GENERATION INTERCONNECTION

REQUEST # GI-2010-11

ADDENDUM TO SYSTEM IMPACT STUDY REPORT

52 MW PV SOLAR, ALAMOSA COUNTY, COLORADO

Fig 1a: Updated Topology

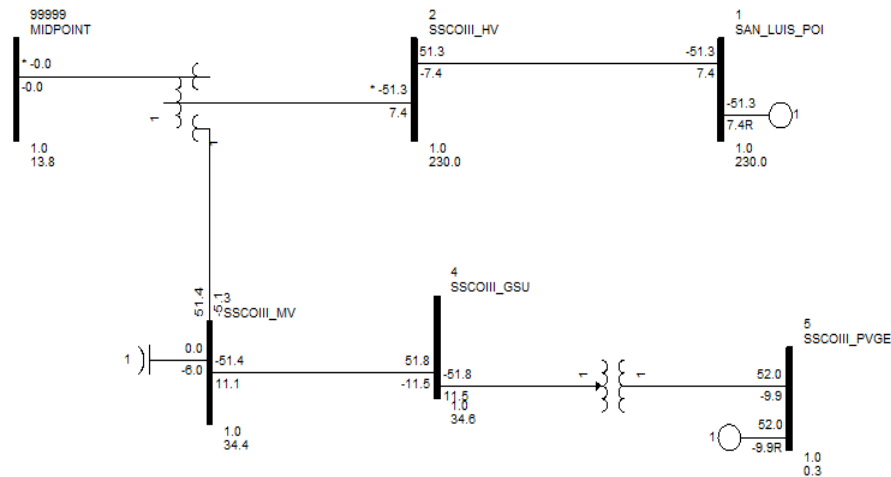
The original modeling information provided by the Customer included a ± 6 MVAR dynamic reactive power device. Thus the GI-2010-11 SIS modeling included this dynamic reactive power device. Subsequent to the completion of the GI-2010-11 SIS, the Customer provided updated modeling. However, the updated modeling, as shown in Figure 1a, provided by the Customer did not include a dynamic reactive power device.

In addition, the Customer will need to confirm the future existence of the ± 6 MVAR dynamic reactive power device as referenced in the model data sheet, but was not in the dynamic PSSE file. Results show that the dynamic reactive power device modeled the transient voltage dip% is within WECC criteria for all the buses shown. However, without the dynamic reactive power device modeled the transient voltage dip% exceeds 25% at one of the buses which is a clear violation of the WECC criterion.

Fig 2a: Plot with Dynamic Reactive Power Device Modeled

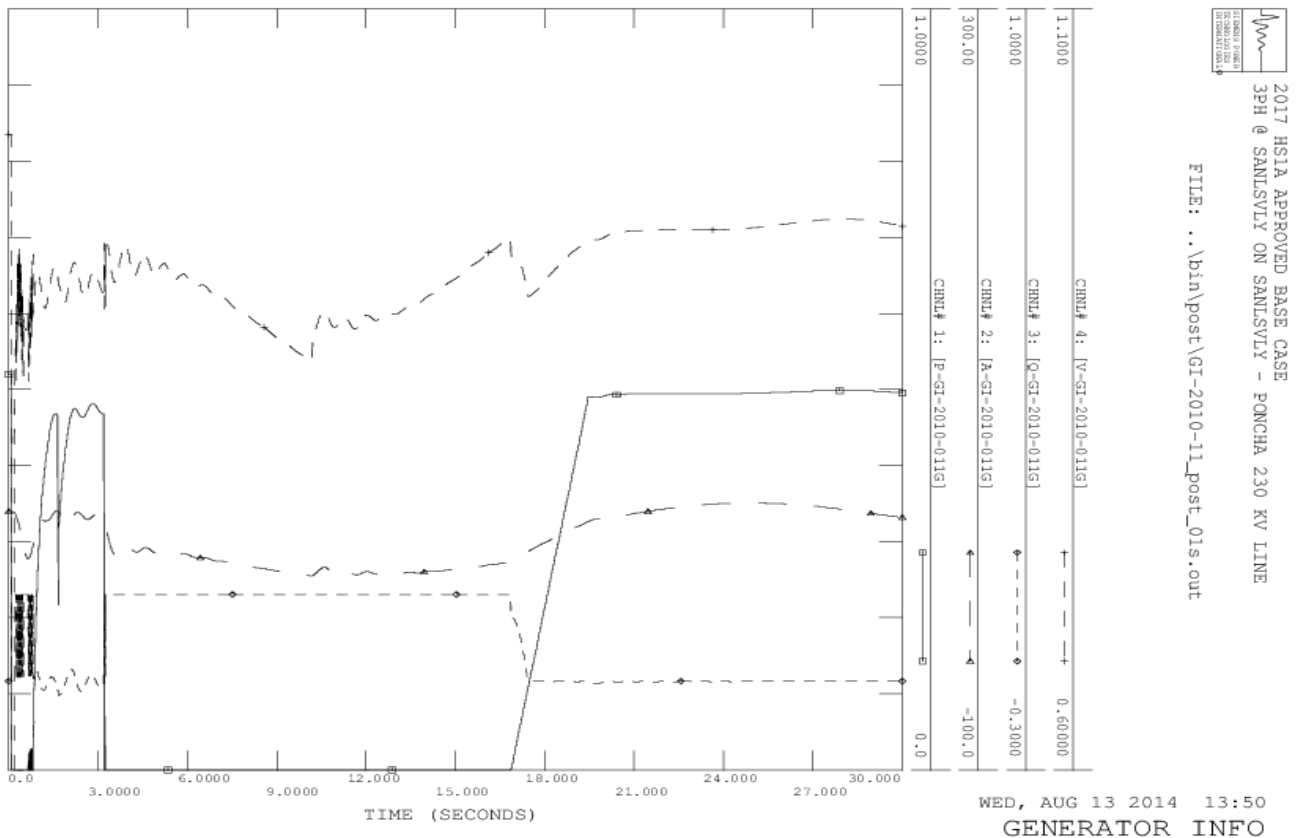
In conclusion, as referenced in Figures 2a and 2b, the power output of the PV inverters goes to zero for a short amount of time (3.5-17 seconds as shown in Figure 2a). From Figure 2a, PSCo concludes that the updated model still does not meet the “Low Voltage Ride Through” criteria and it is not an acceptable generator output performance. The trip of the GI-2010-11 generation and the transient voltage criteria violation following the Disturbance 1s are criteria violations which must be mitigated.

As seen in Fig 2a, with the dynamic reactive power device modeled, the power output of the PV inverters goes to zero from approximately 3.5 to 17 sec and then recovers for the 01s disturbance simulation. PSCo should determine if this generation output performance is acceptable for a new generator seeking interconnection to the PSCo transmission system. No other potential criteria violations were identified.

As mentioned in the SIS report meeting on July 15th, 2014, PSCo Planning and Operations notified the Customer that they would prefer them to operate the photovoltaic inverters in voltage control mode which is QVAR mode #3. The SIS report has demonstrated that the QVAR mode #3, voltage control mode, has positive effect on the bulk electric system and will enable the Plant to ride through some of the most critical faults in the San Luis Valley area.

Fig 2b: Plot without Dynamic Reactive Power Device Modeled

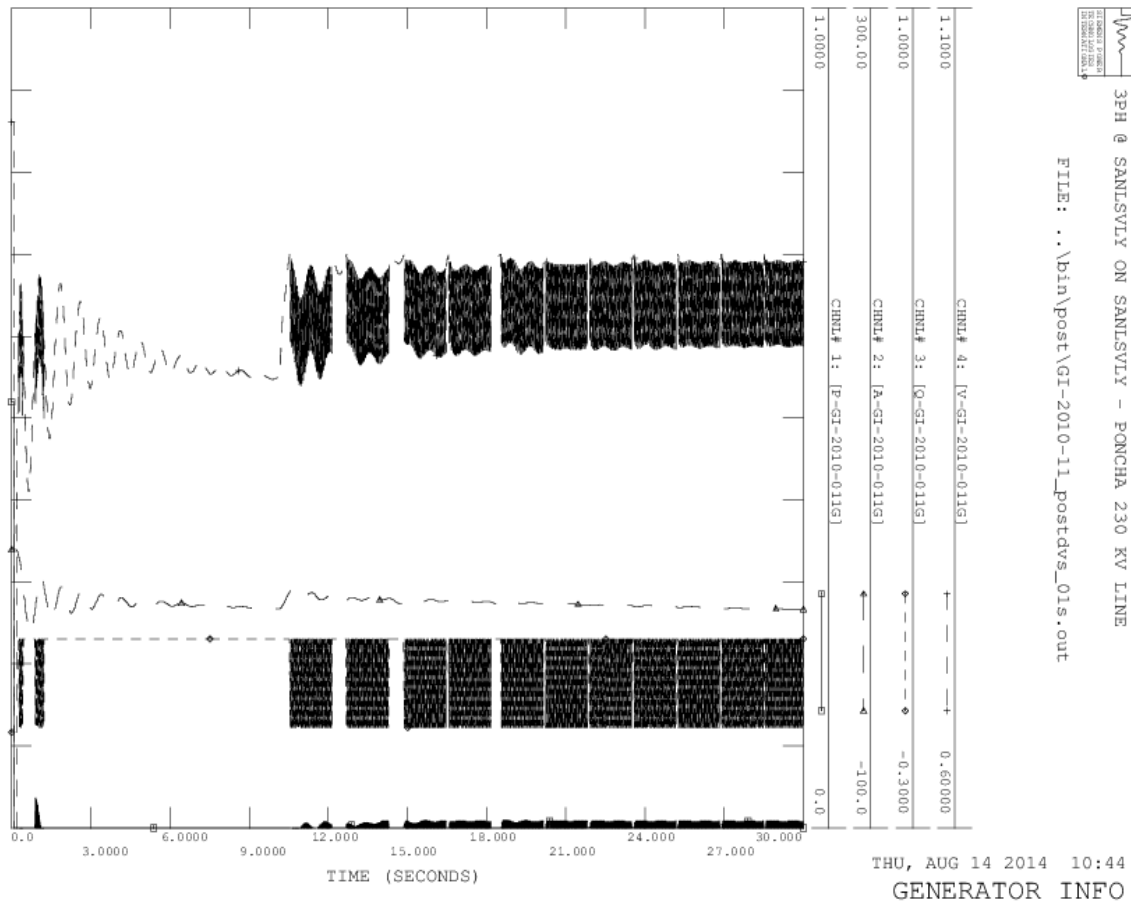
As seen in Fig 2b, without the dynamic reactive power device modeled, the power output of the PV inverters goes to zero and does not recover within 30 seconds. Thus the GI-2010-11 generation trips following the Disturbance 1s if the dynamic reactive power device is not modeled. In addition the table below shows that a transient voltage criteria violation also occurs following the Disturbance 1s if the dynamic reactive power device is not modeled. The trip of the GI-2010-11 generation and the transient voltage criteria violation following the Disturbance 1s are criteria violations, which must be mitigated.

It can be seen that with the dynamic reactive power device modeled the transient voltage dip% is well within WECC criteria for all the buses shown. Without the dynamic reactive power device modeled the transient voltage dip% exceeds 25% at the FT GARLAND 69 kV bus, which is a clear violation of the WECC criterion.

Fig 3a: Plot with Dynamic Reactive Power Device Modeled

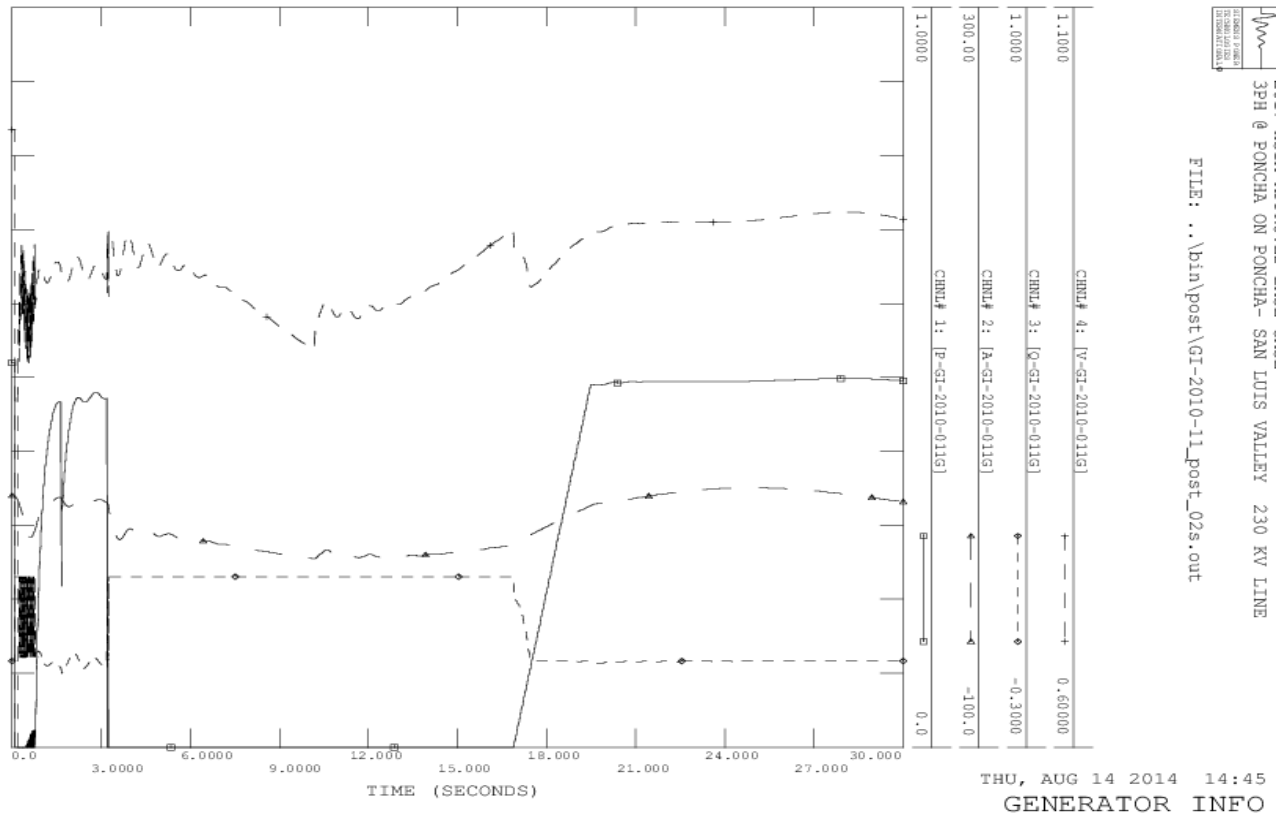
As seen in Fig 3a, with the dynamic reactive power device modeled, the power output of the PV inverters goes to zero from approximately 3.5 to 17 sec and then recovers for the 02s disturbance simulation. PSCo should determine if this generation output performance is acceptable for a new generator seeking interconnection to the PSCo transmission system. No other potential criteria violations were identified.

Fig 3b: Plot without Dynamic Reactive Power Device Modeled

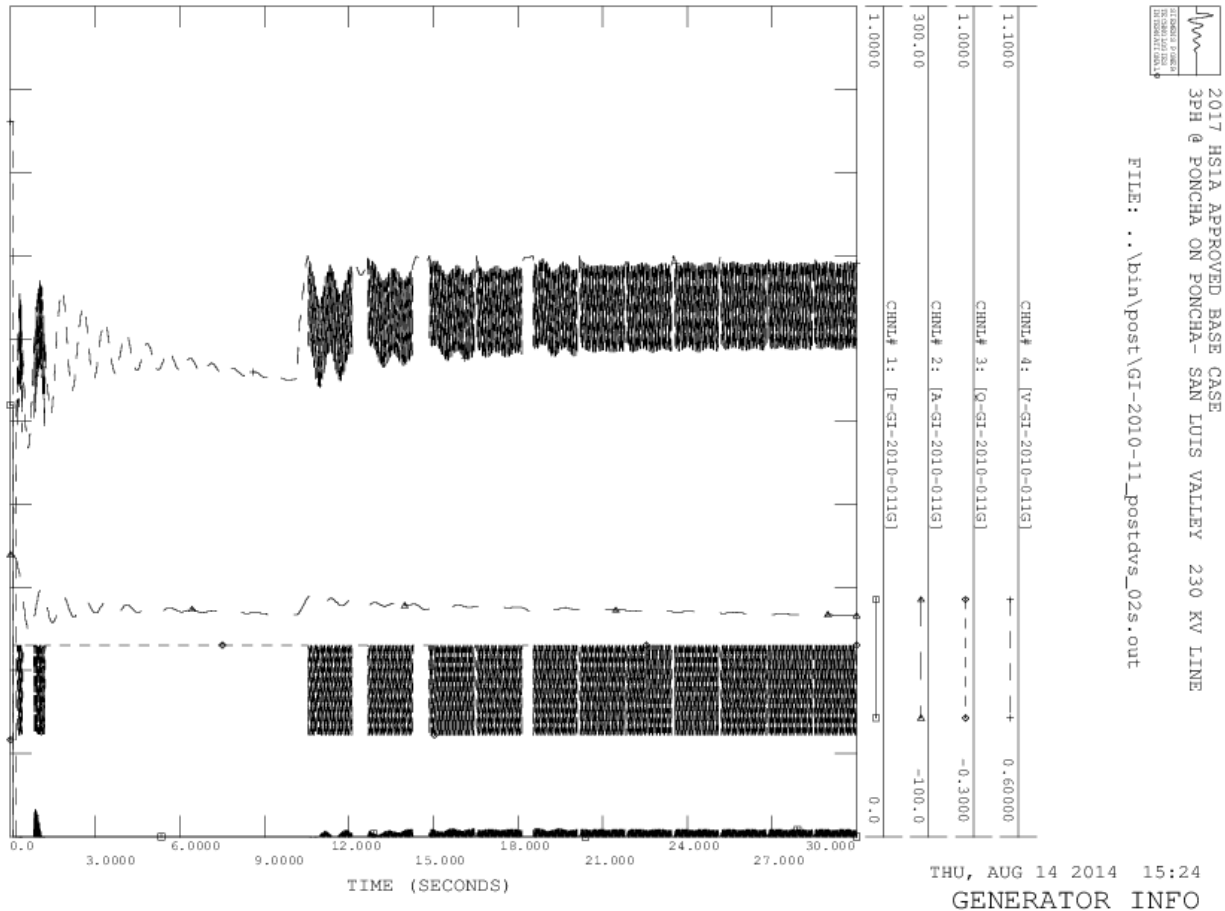
As seen in Fig 3b, without the dynamic reactive power device modeled, the power output of the PV inverters goes to zero and does not recover within 30 seconds. Thus the GI-2010-11 generation trips following the Disturbance 2s if the dynamic reactive power device is not modeled. Also shown in Figure 3b, significant oscillations result if the dynamic reactive power device is not modeled. The trip of the GI-2010-11 generation and the oscillations following the Disturbance 2s are criteria violations, which must be mitigated. No other potential criteria violations were identified.
